# **RANCH PLAN**

# **Alternative Development Standards**

March 14, 2007  
Amended August 12, 2008 | Amended September 14, 2011 | Amended December 14, 2011  
Amended March 15, 2012 | Amended July 24, 2013 | Amended November 14, 2014  
Amended May 27, 2015 | Amended September 26, 2018

## Ranch Plan Alternative Development Standards Approvals Summary

### THE RANCH PLAN ALTERNATIVE DEVELOPMENT STANDARDS

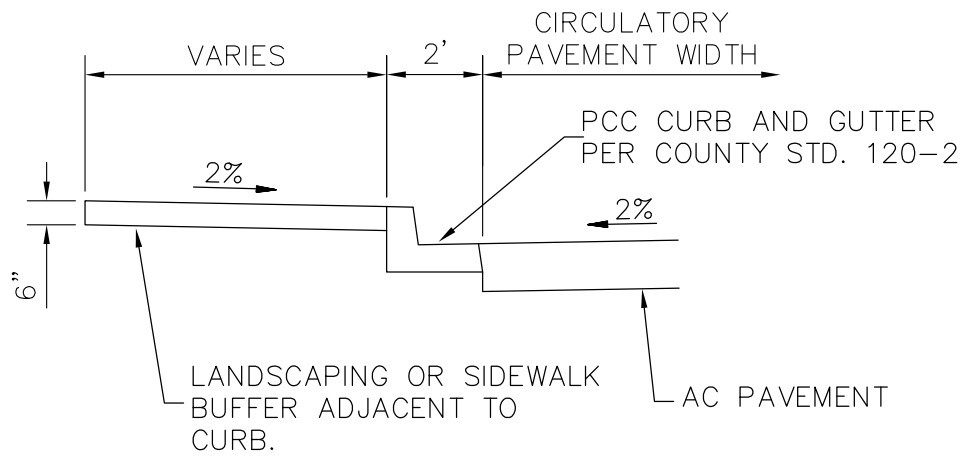
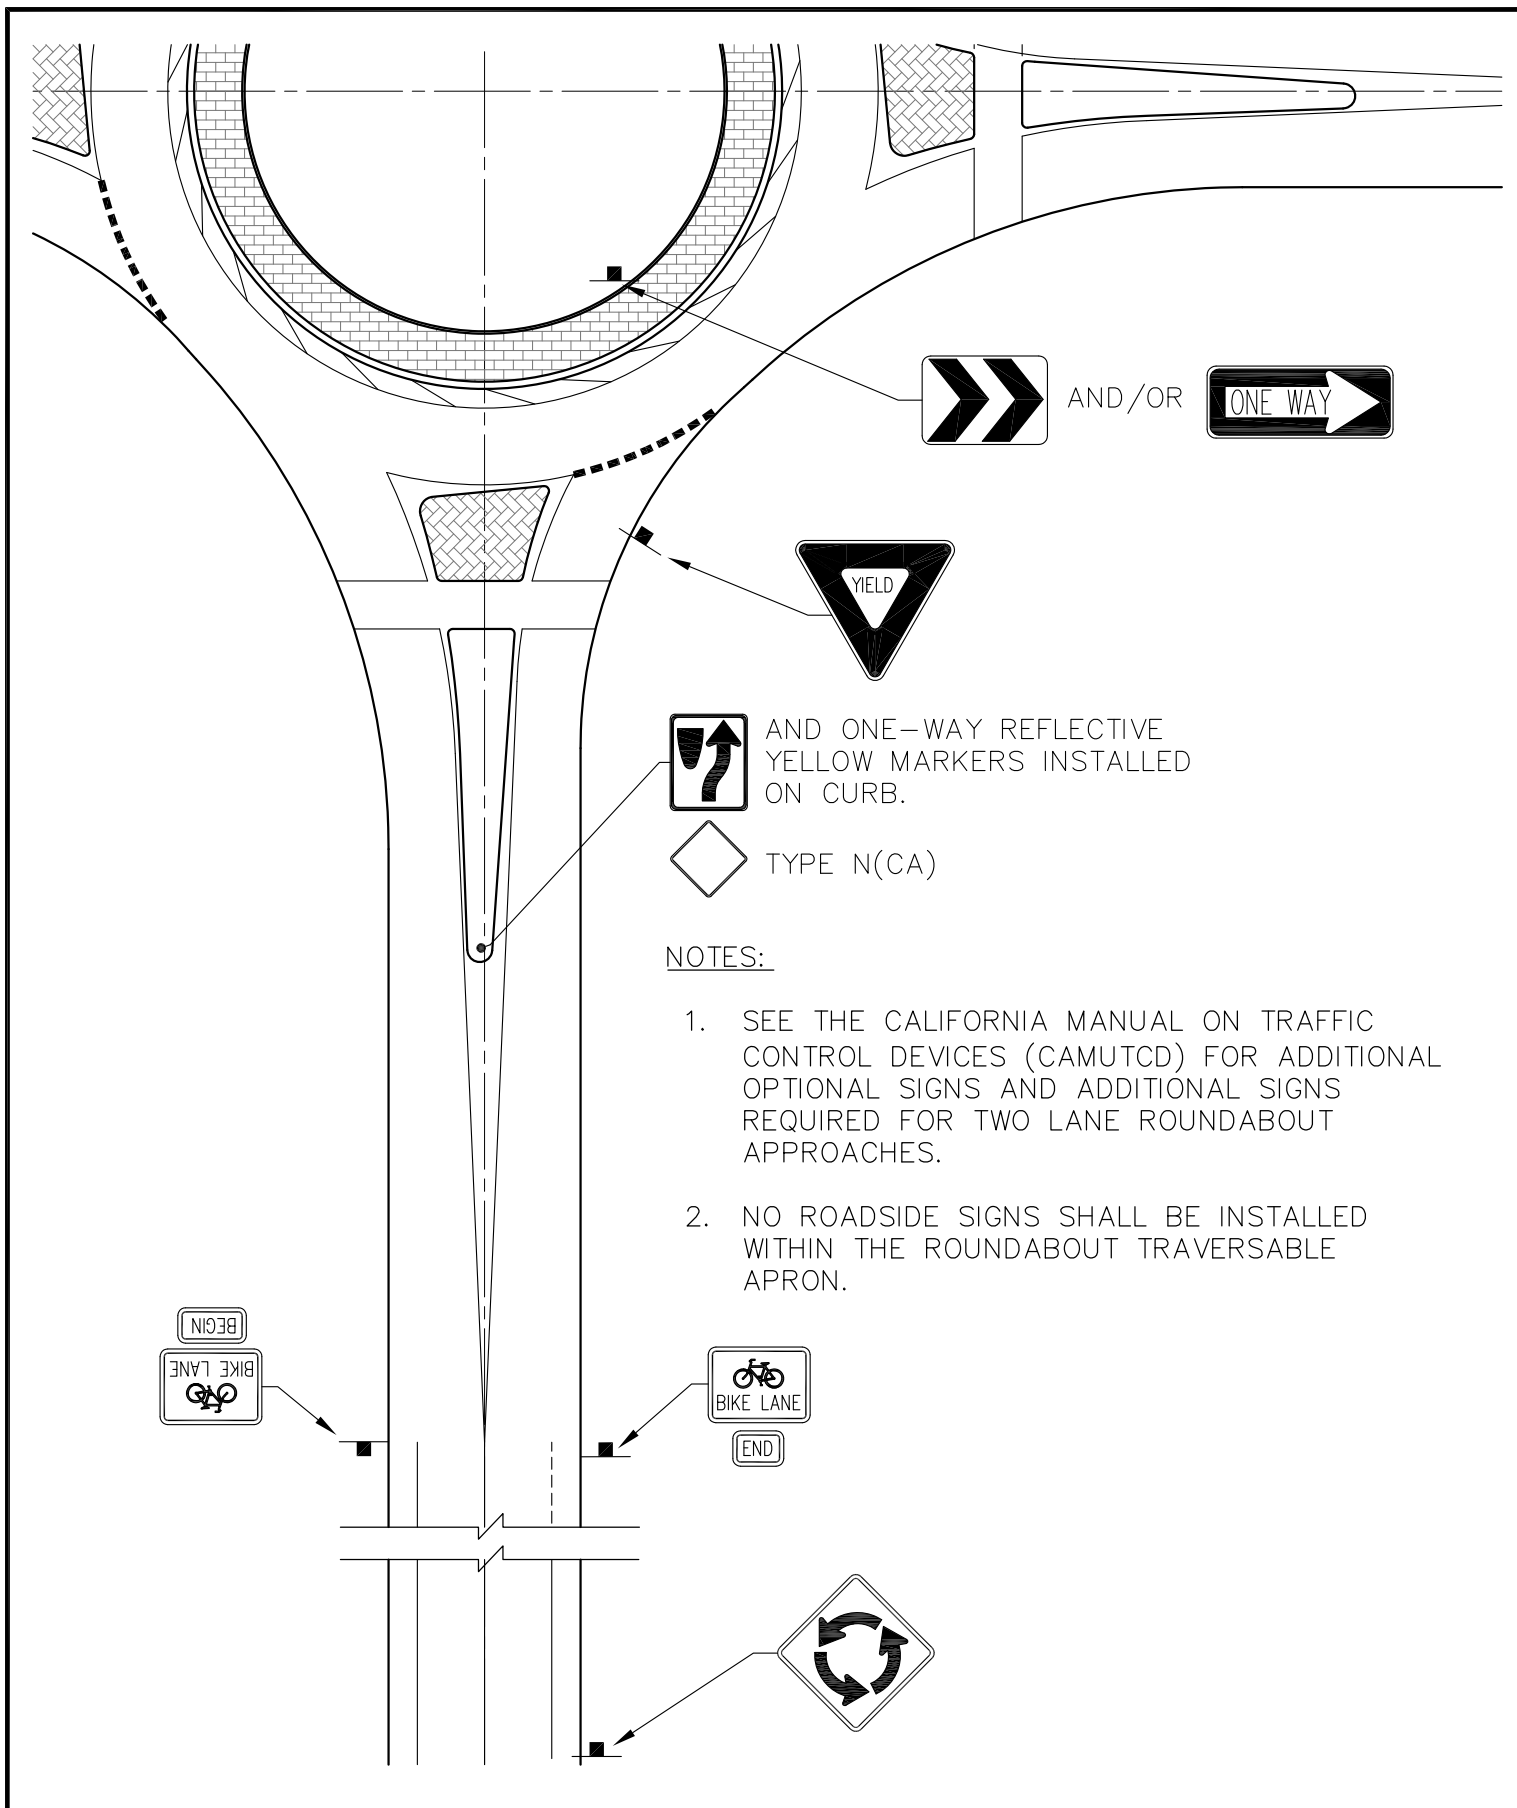
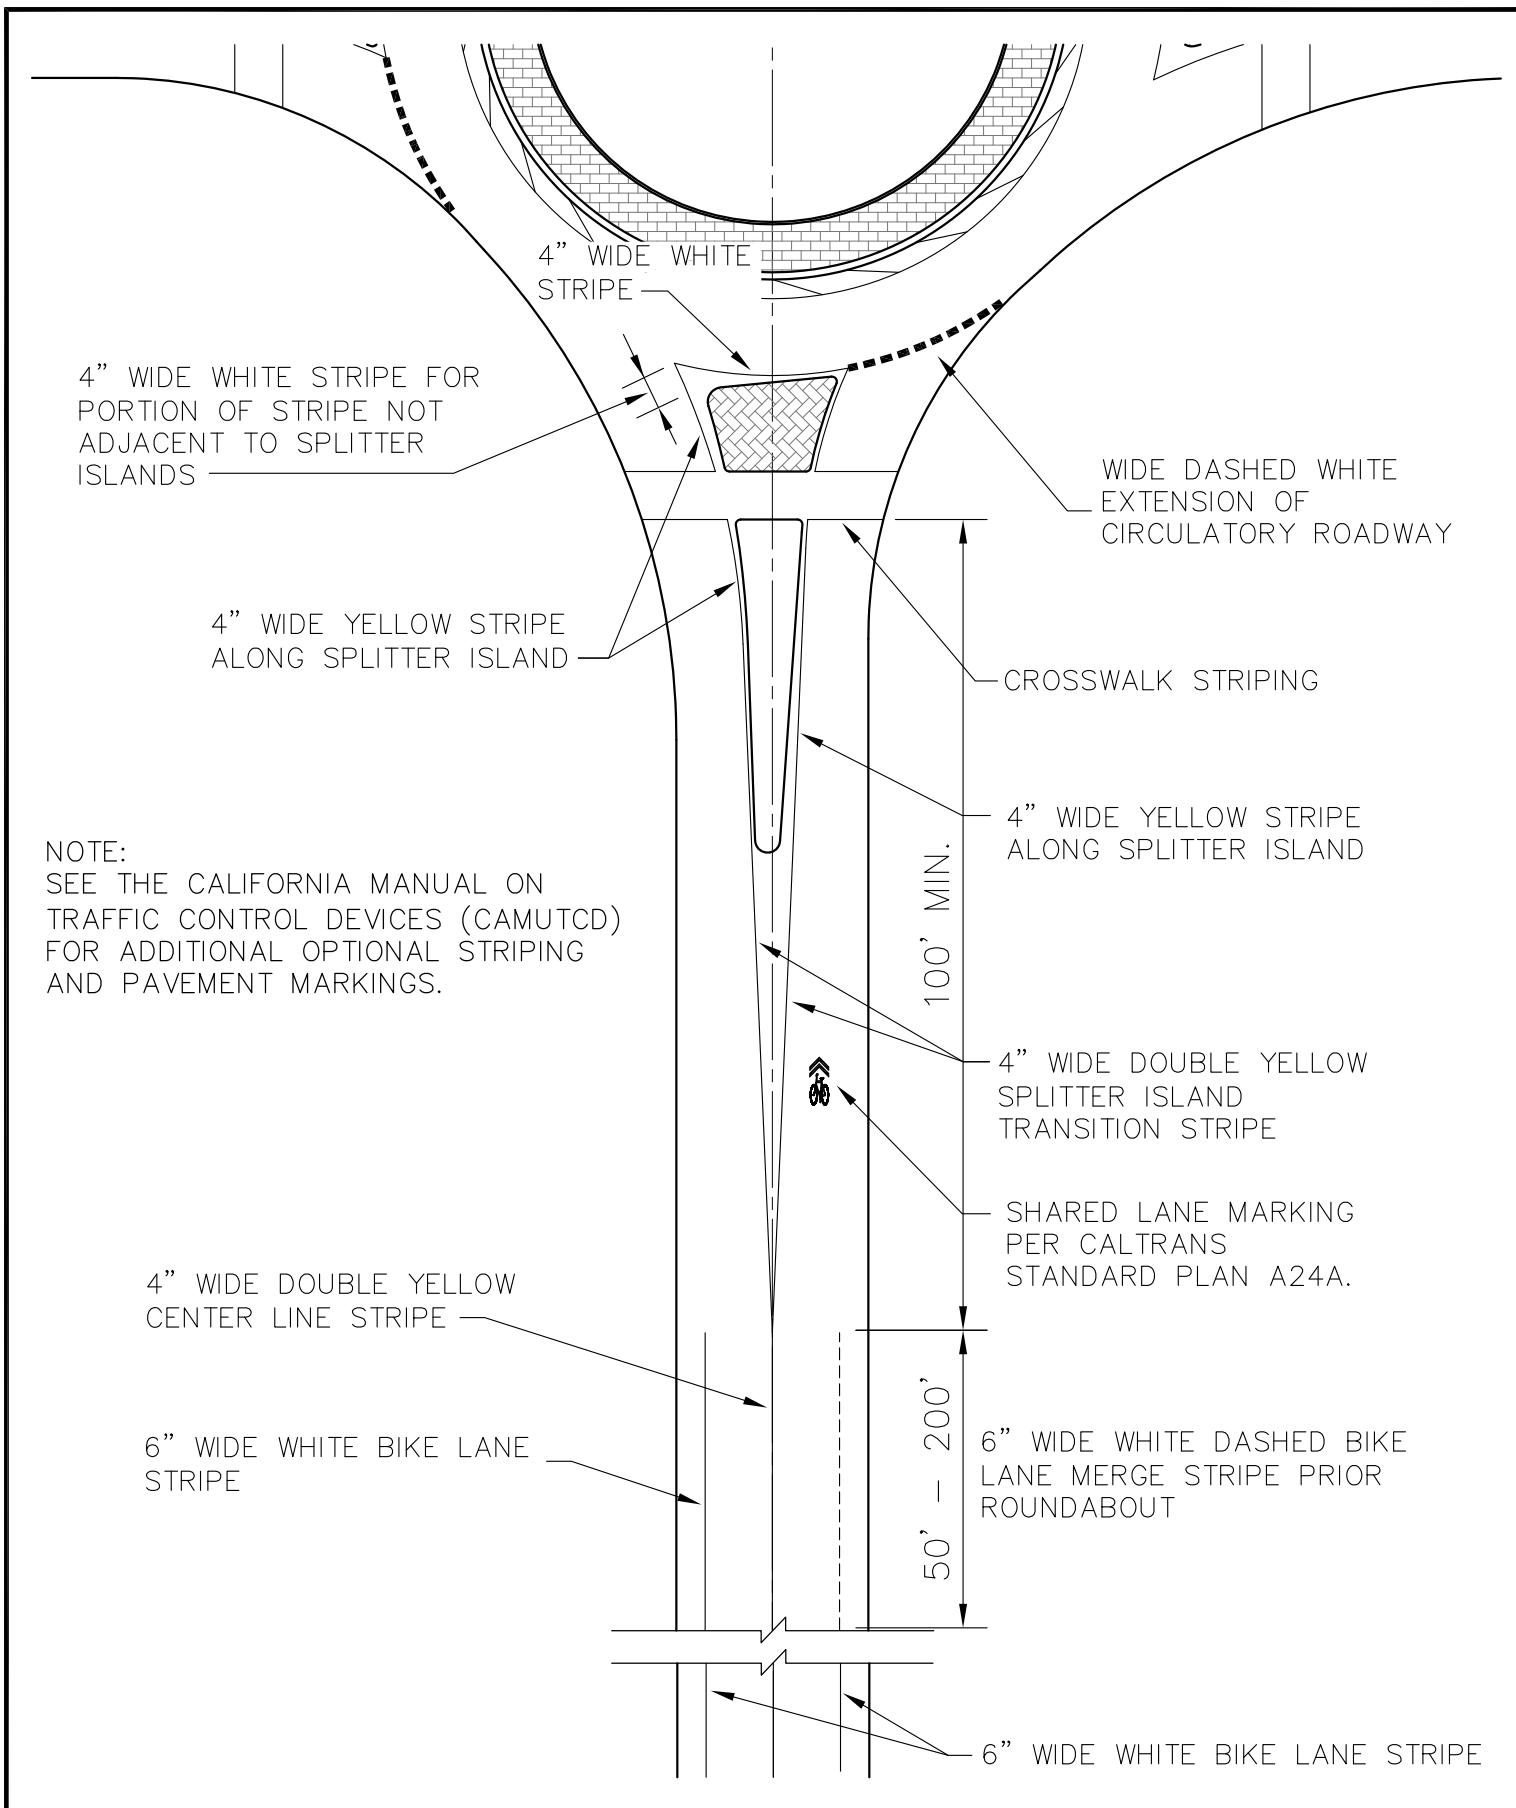
Sheet 1:

Sheet 3: (Previous Sheet 5)

1. Revised and added new dimensions associated with updates to sheets 1 and 2.
2. Added crosswalk setback dimensions based on proximity to schools, recreational, commercial and secondary highway areas.

Sheet 4 (Previous Sheet 3):

1. Removed outside OCFA vehicle apron.
2. Revised roundabout layout to reflect changes on sheet 1.
3. Moved corner right-of-way lines outside the approach and departure sight distance areas.

Sheet 7 (Previous Sheet 4):

Sheet 8 (Previous Sheet 6):

1. Changed detail title from "Wedge Curb detail" to "Truck Apron Detail".
2. Revised detail to remove armored pavement and specified traversable truck apron pavement treatment must be capable of supporting OCFA vehicles.
3. Mirrored detail to match the section callouts on sheet 1 and 2.
4. Added Note 3: Median island landscape shall be designed with area drain system to capture surface drainage (to be shown on landscape plans).
5. Added Note 4: Soil conditions within median island may determine need for additional sub-drain systems.

Sheet 9 (Previous Sheet 7):

1. B-6 – Roundabouts: A proposed modification to the roundabout concrete gutter detail to add a one-inch “batter” (Sheet 7 of 8), per the request of the Manager of Inspection Services.
